CONSTRUCTION DRAWINGS FOR REX ROAD AT FALCON REGIONAL PARK IMPROVEMENT PLANS

REX ROAD
 AT FALCON REGIONAL PARK
 STREET AND UTILITY PLANS
 COVER SHEET

COUNTY PLAN REVIEW IS PROVIDED ONLY FOR GENERAL CONFORMANCE WITH COUNTY DESIGN CRITERIA. THE COUNTY IS NOT RESPONSIBLE FOR THE ACCURACY AND ADEQUACY OF THE DESIGN, DIMENSIONS, AND/OR ELEVATIONS WHICH SHALL BE CONFIRMED AT THE JOB SITE. THE COUNTY THROUGH THE APPROVAL OF THIS DOCUMENT ASSUMES NO RESPONSIBILITY FOR COMPLETENESS AND/OR ACCURACY OF THIS DOCUMENT.

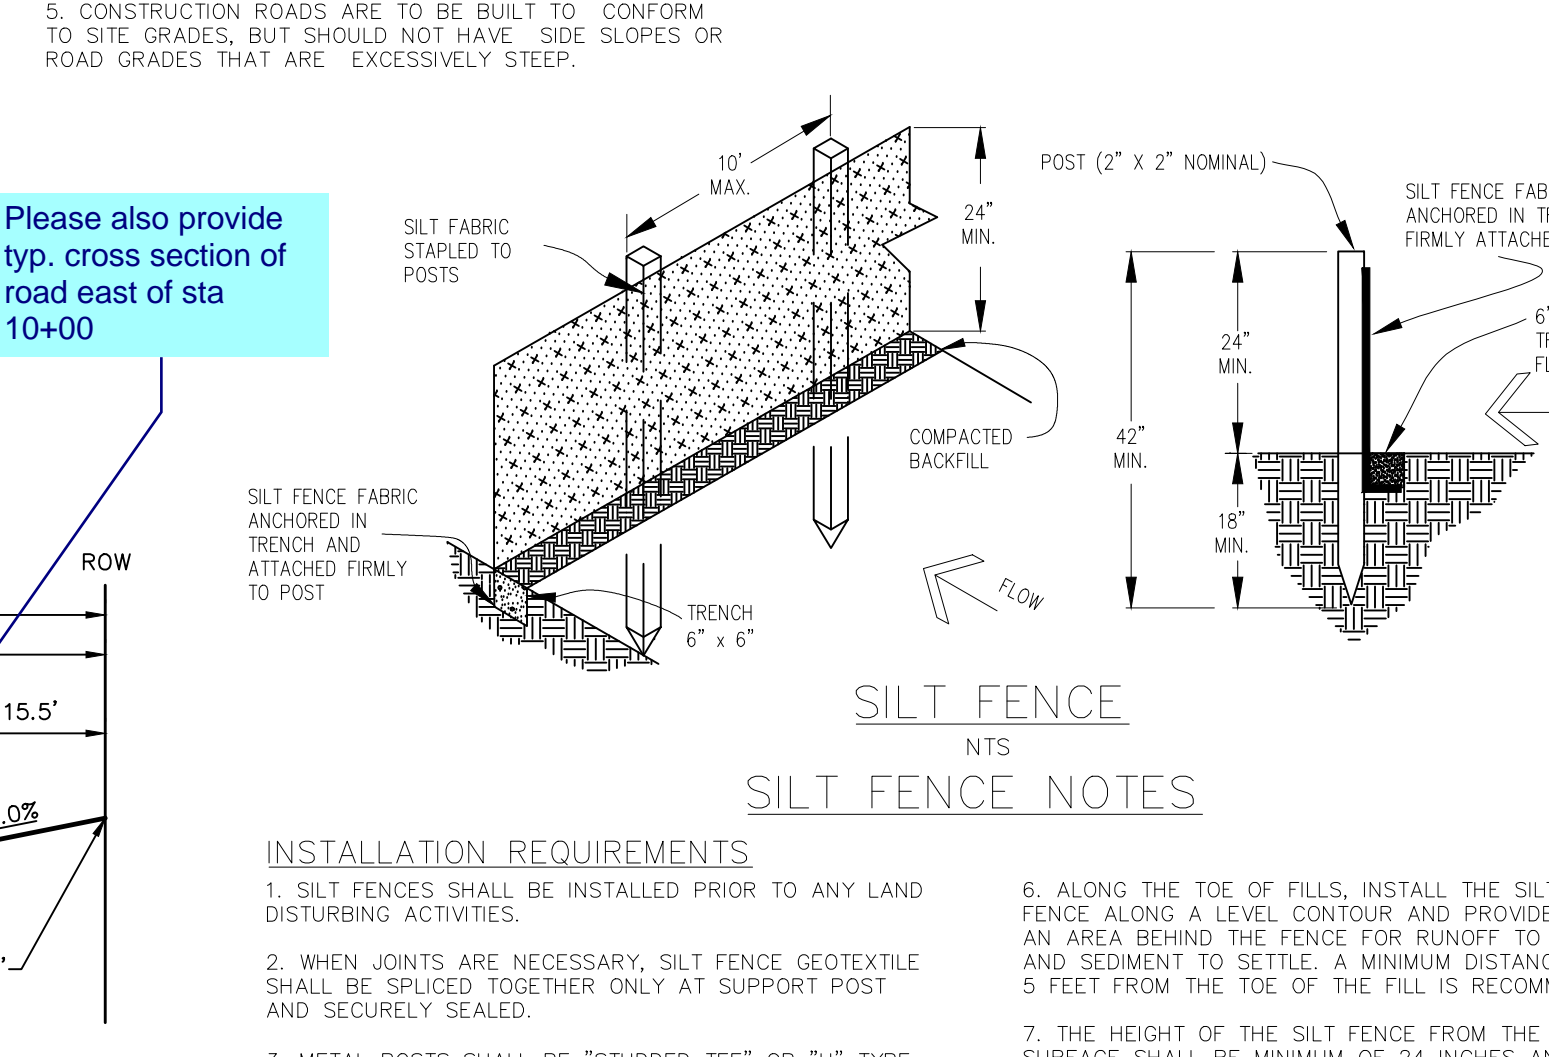
Please also provide typ. cross section of road east of sta 10+00

include detail for permanent seeding and mulching
Include detail for ECB
Include TSB Details
